# SUBDIVISION REPORT - CONCEPT/DEVELOPMENT PLAN

▶ **FILE #:** 1-SF-23-C  
1-E-23-DP

▶ **SUBDIVISION:** BEELER ROAD SUBDIVISION  
▶ **APPLICANT/DEVELOPER:** MESANA INVESTMENTS - BEELER ROAD  
**OWNER(S):** Mesana Investments, LLC

CONCEPT & DEVELOPMENT PLAN FOR  
**MESANA INVESTMENTS-BEELER ROAD**

ROAD PROFILES FOR  
MESANA INVESTMENTS-BEELER ROAD  
TAX MAP 29, PART OF PARCEL 188.03  
DISTRICT 6, KNOX COUNTY, TENNESSEE

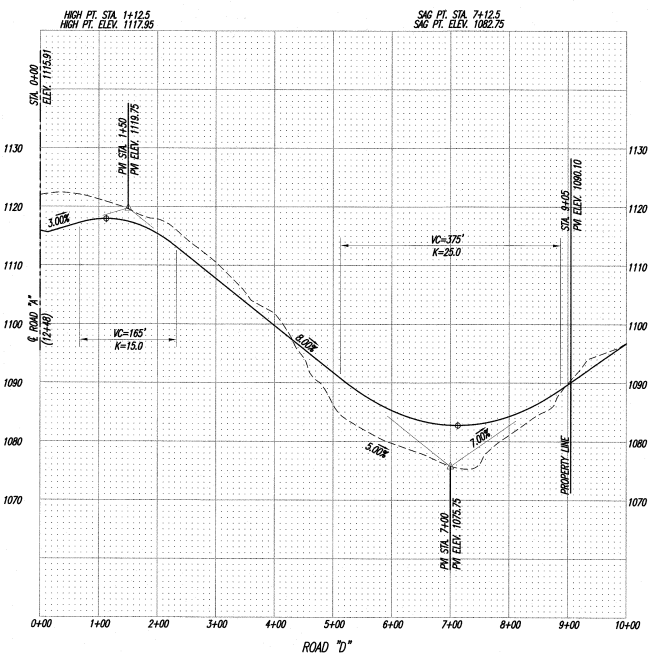
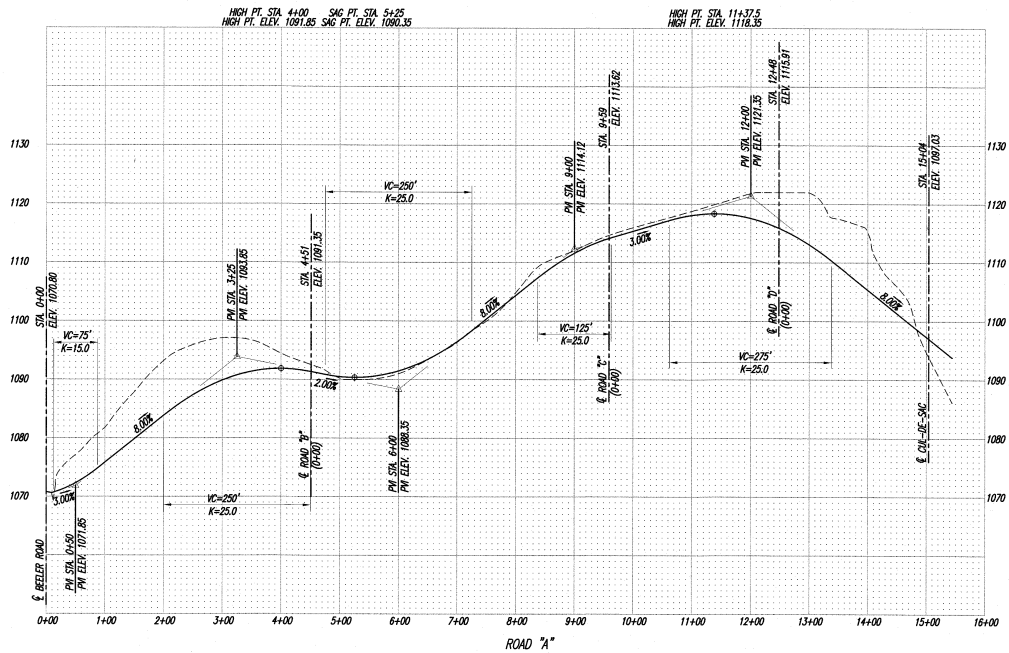
▶ **SUBDIVISION VARIANCES REQUIRED:** **VARIANCES**  
1. Reduce the minimum vertical curve on Road 'A' from K=25 to K=15 at STA 0+75

1. Reduce the minimum horizontal curve radius from 250' to 150' at STA 2+25 on Road 'D'

1. Reduce the minimum vertical curve on Road 'A' from K=25 to K=15 at STA 0+75

1. Reduce the minimum horizontal curve radius from 250' to 150' at STA 2+25 on Road 'D'

1. Increase the maximum intersection grade from 1% to 3% on Road 'A' at Beeler Road
2. Increase the maximum intersection grade from 1% to 3% on Road 'B' at Road 'A'
3. Increase the maximum intersection grade from 1% to 2% on Road 'C' at Road 'A'
4. Increase the maximum intersection grade from 1% to 3% on Road 'D' at Road 'A'

#### KNOX COUNTY ENGINEERING AND PUBLIC WORKS RECOMMENDATION:

Approve.  
  1/3/23

\* The maximum intersection grade is 2% when there is a pedestrian crosswalk.
